Duke Energy Ohio
Case No. 19-1471-EL-BLN
STAFF Second Set of Data Requests B
Date Received: Wednesday, November 6, 2019

STAFF-DR-02-001 B

DATE: 11/7/2019
APPROVED: MWW

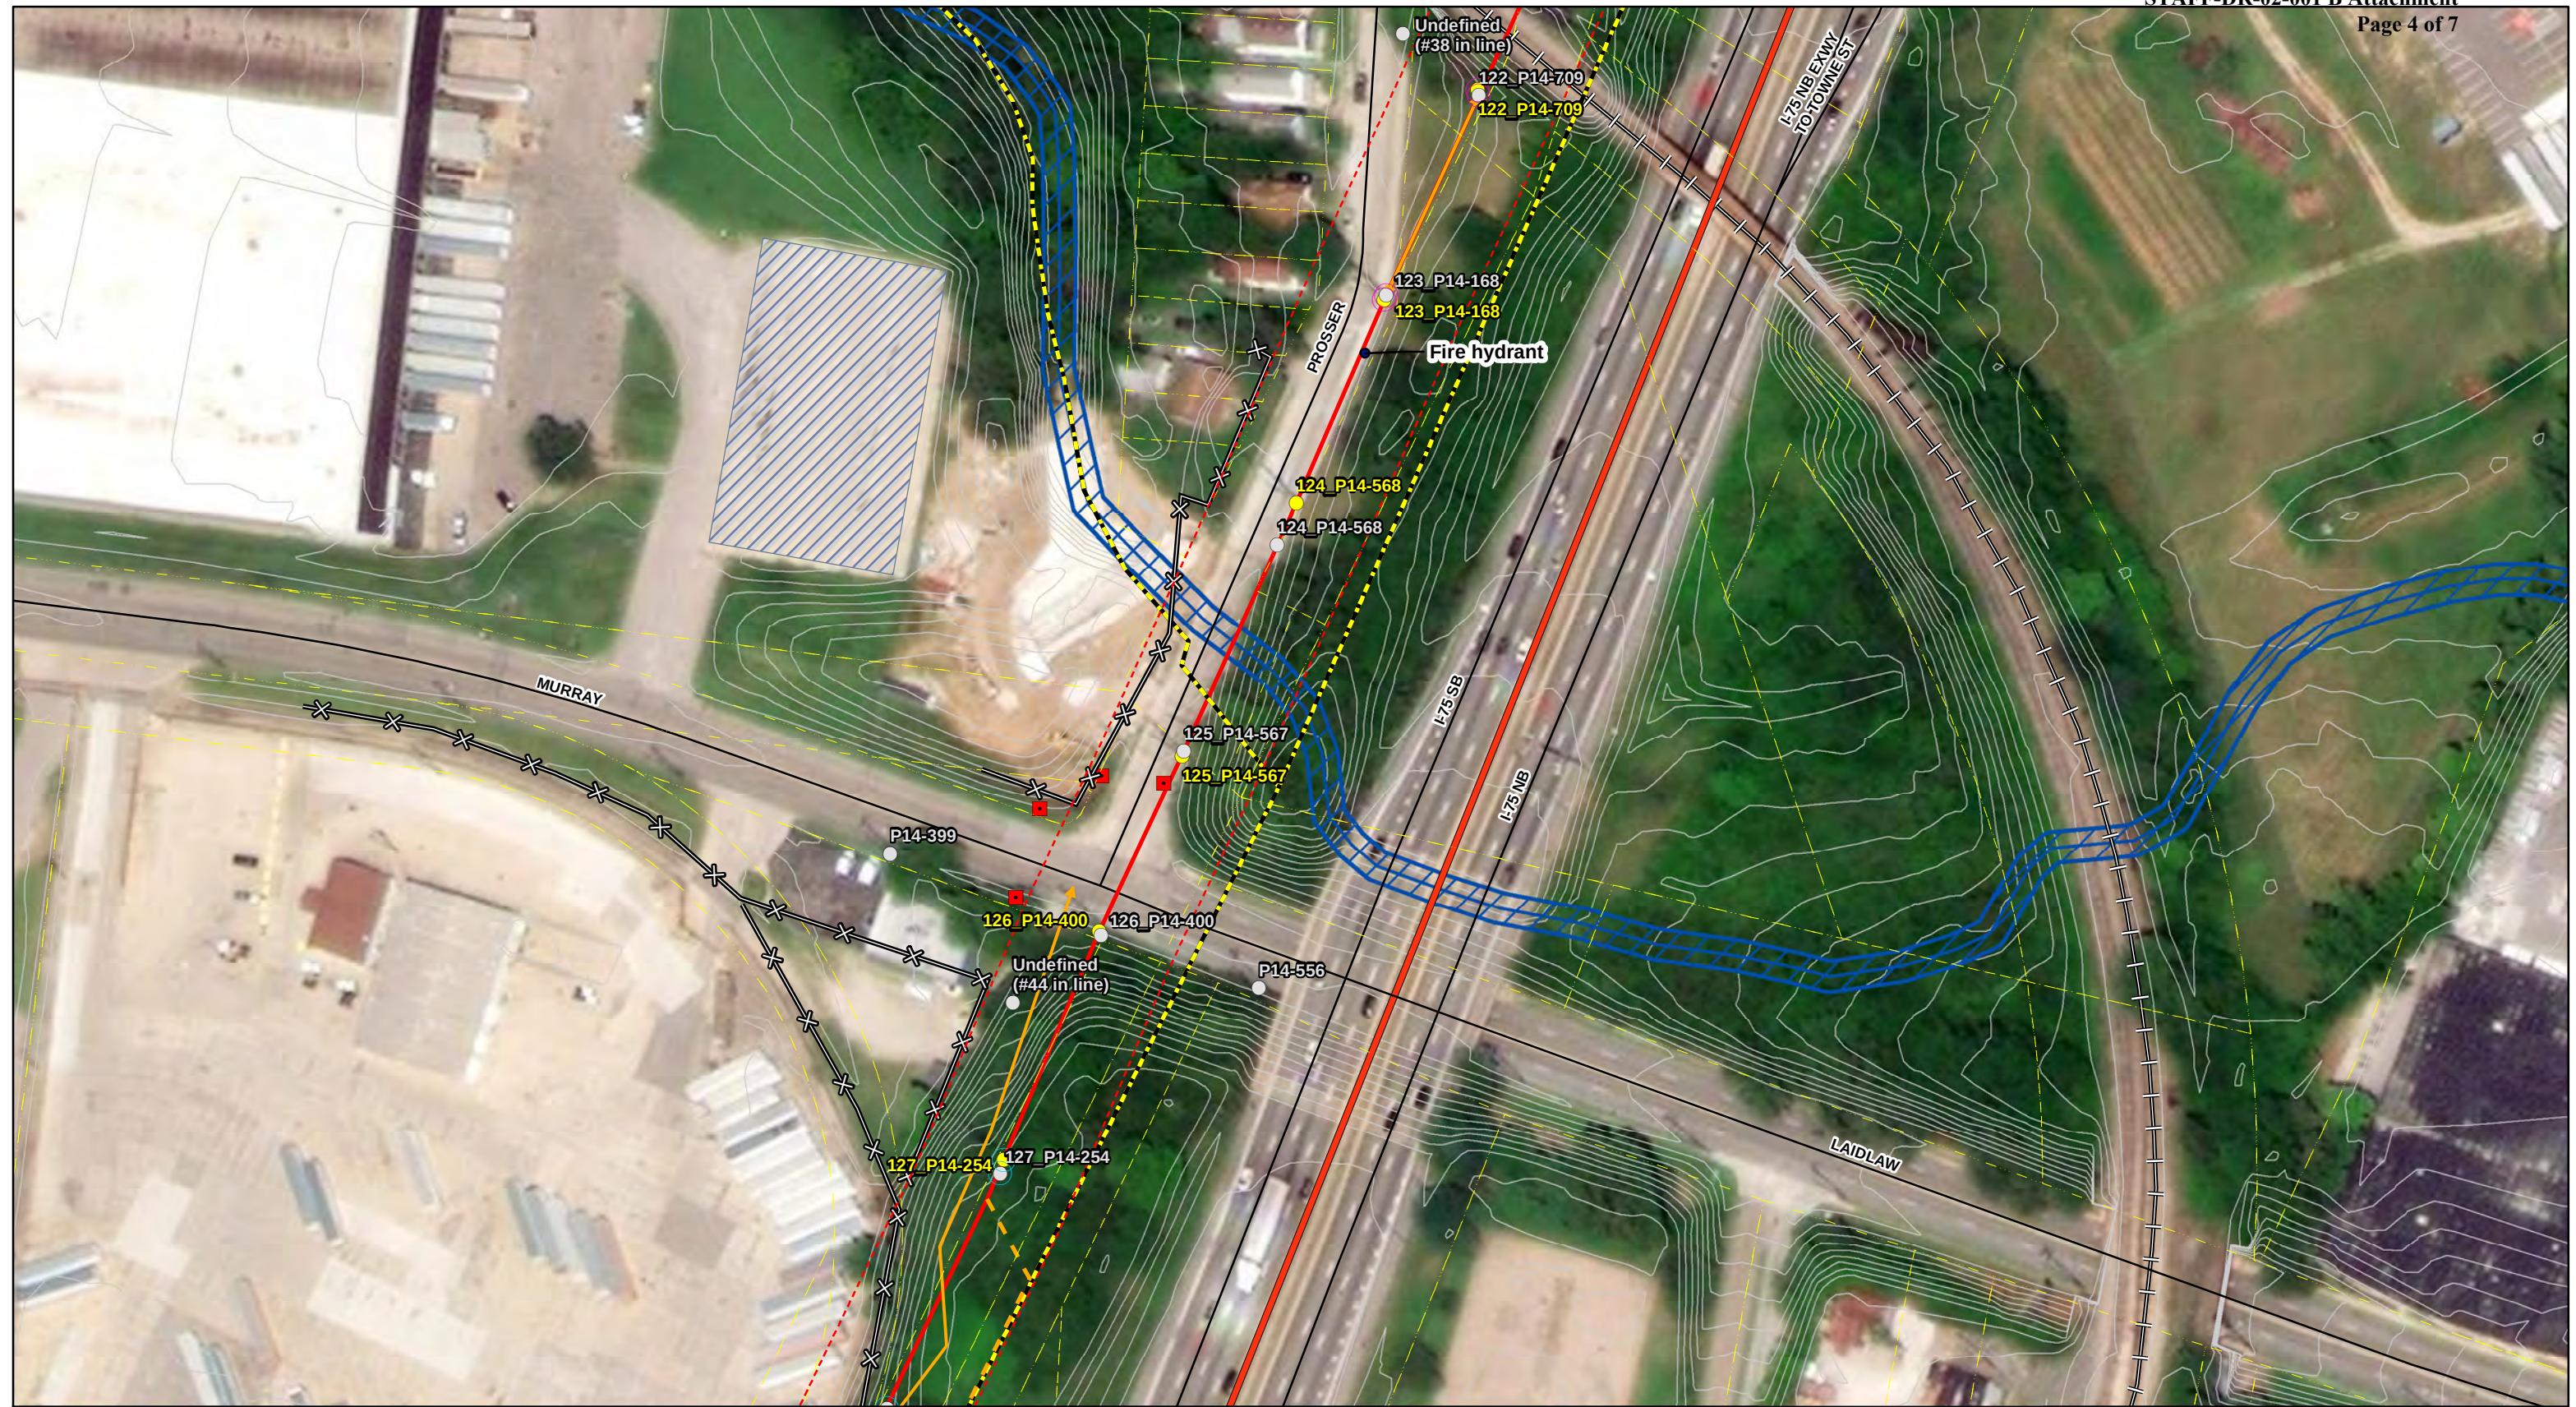
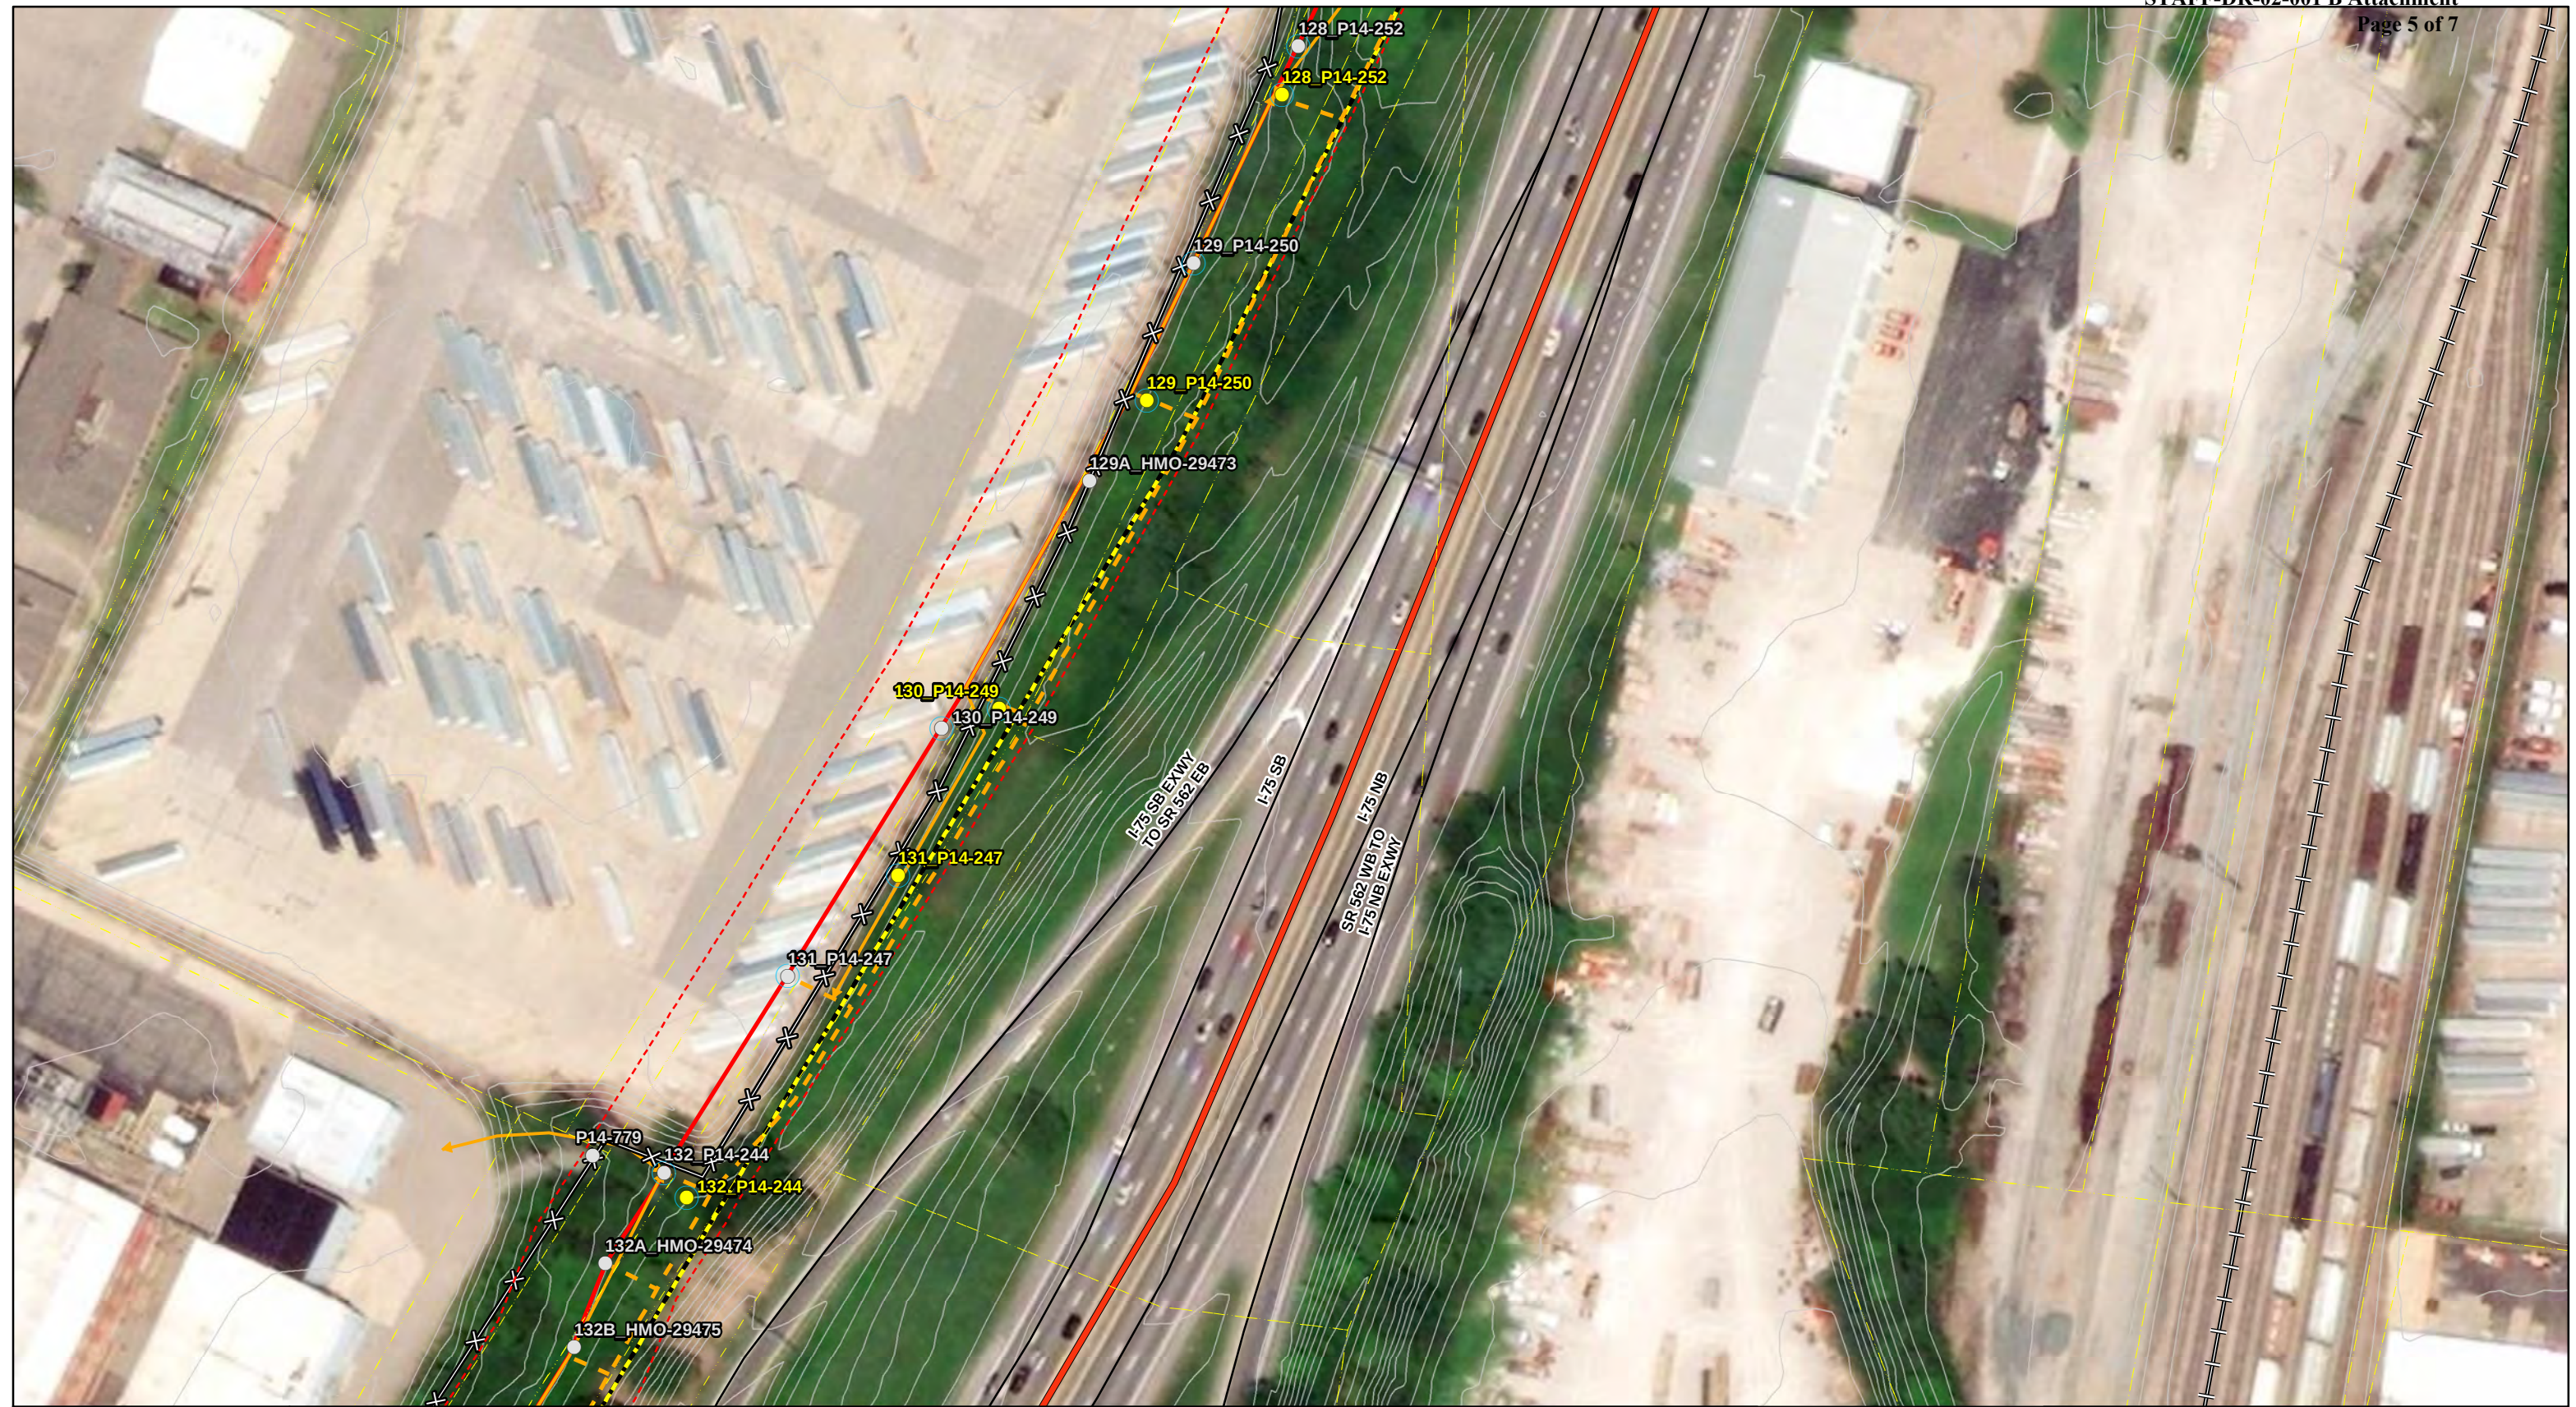
Staff is looking for clarification on the structures ODOT is requiring Duke to relocate, and the distances between the existing and new structure locations.

1. Can you provide to Staff the number of structures ODOT is requiring relocation of?
 - a. The structure numbers and a corresponding map for Staff to review of those structures, and the distances between the existing and new structures for Staff to review?

The following is a list of the reasons for changing the various poles involved in the project, impacted by : uplift and age

- A. These poles are required to move as far west as possible due to SR562 on ramp conflicts:
 - 684-P14-242
 - 684-P14-244
 - 684-P14-247
 - 684-P14-249
 - 684-P14-250
 - 684-P14-252
 - 684-P14-254
 - 684-P14-598
- B. These poles are required to be raised in height to accommodate anticipated future railroad crossing construction and operations:
 - 684-P14-707
 - 684-P14-708
 - 684-P14-709
 - 684-P14-168
- C. These poles are required to be moved West in addition to be raised vertically for construction clearances. ODOT plans to reconstruct the bridge structure.
 - 684-P14-275
 - 684-P14-705

D. These poles are in direct conflict with the proposed sound wall for I75:

- 684-P15-483
- 684-P15-647
- 684-P15-655
- 684-P15-656
- 684-P15-657

With regard to the remaining poles, the increased pole heights associated with the changes listed above require other nearby poles to also be replaced with taller poles. This is the basis for their inclusion in this project.

The following table sets forth, for each pole, whether it is a new pole or, if not, how far it will be from existing poles:

POLE NUMBER	DISTANCE FROM OLD POLE (FT)
103_P15-559	3
P13-560	3
P13-738	3
104_P15-490	3
105_P15-659	2
P15-661	3
106_P15-657	4
106A_HMO-29466	NEW POLE
107_P15-656	3
108_P15-655	4
109_P15-647	4
110_P15-483	3
110A_HMO-29467	NEW POLE
111_P15-352	3
P15-354	3
112_P15-369	31
112A_HMO-29468	NEW POLE
113_P15-368	52
114_P15-367	73
115_P15-365	39
116_P14-424	32
HMO-29469	NEW POLE
116A_HMO-29470	NEW POLE
117_P14-275	12
117A_HMO-29471	NEW POLE
117B_HMO-29472	NEW POLE
118_P14-705	5
119_P14-706	5

120_P14-707	3
121_P14-708	3
122_P14-709	4
123_P14-168	3
124_P14-568	29
125_P14-567	3
126_P14-400	4
127_P14-254	12
128_P14-252	34
129_P14-250	92
129A_HMO-29473	NEW POLE
130_P14-249	39
131_P14-247	94
132_P14-244	21
132A_HMO-29474	NEW POLE
132B_HMO-29475	NEW POLE
133_P14-242	9
133A_HMO-29485	NEW POLE
134_P14-598	4
135_P14-575	3
136_P13-117	3
137_P13-497	6
138_P13-111	5

Attached as Staff-DR-02-001 B Attachment is a map showing existing lines and structures, proposed lines and structures, and the rail crossing, together with an identification of which poles are being replaced at the direct request of ODOT.
